# Origination Form

## Proposed Revisions to a Standard Plans Index

| <b>Originator:</b> | Turley, Joshua                | <b>Index Number:</b>    | 455-112                                           |
| <b>E-mail:</b>     | Joshua.Turley@dot.state.fl.us | <b>Index Title:</b>     | 12" SQUARE CFRP & SS<br>PRESTRESSED CONCRETE PILE |

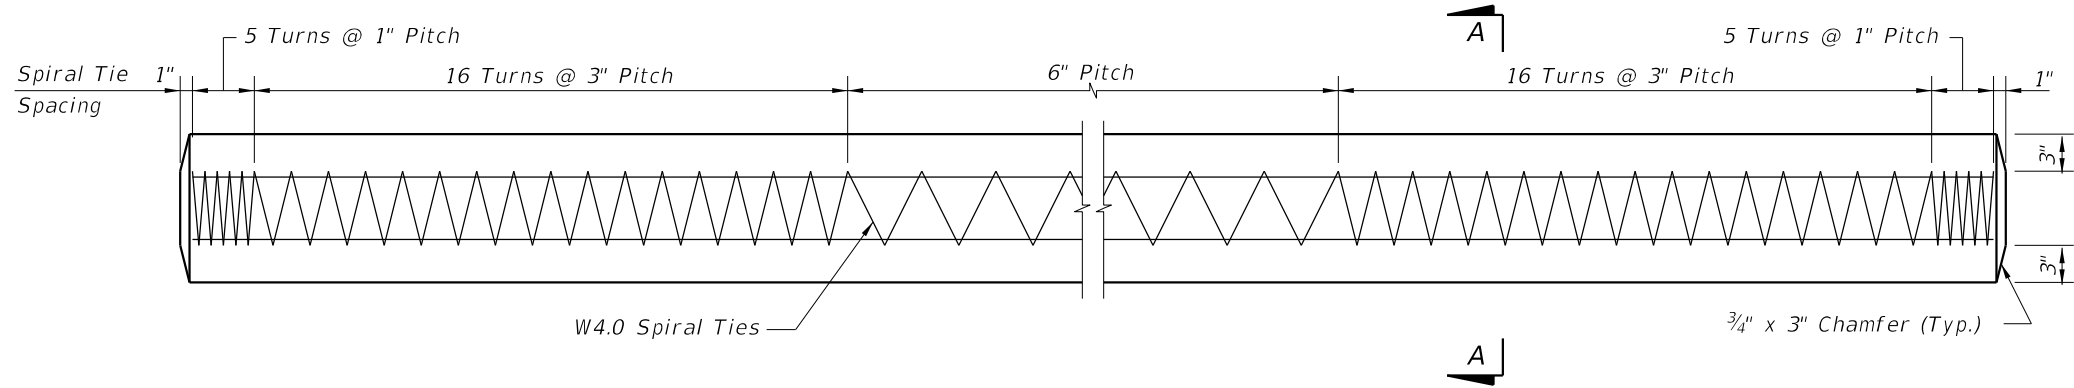
Sheet 2: Adjusted Strand Pattern diameter decimal places

This is a more accurate representation of the nominal diameter driven by the fact that the strands are fabricated in millimeters not inches.
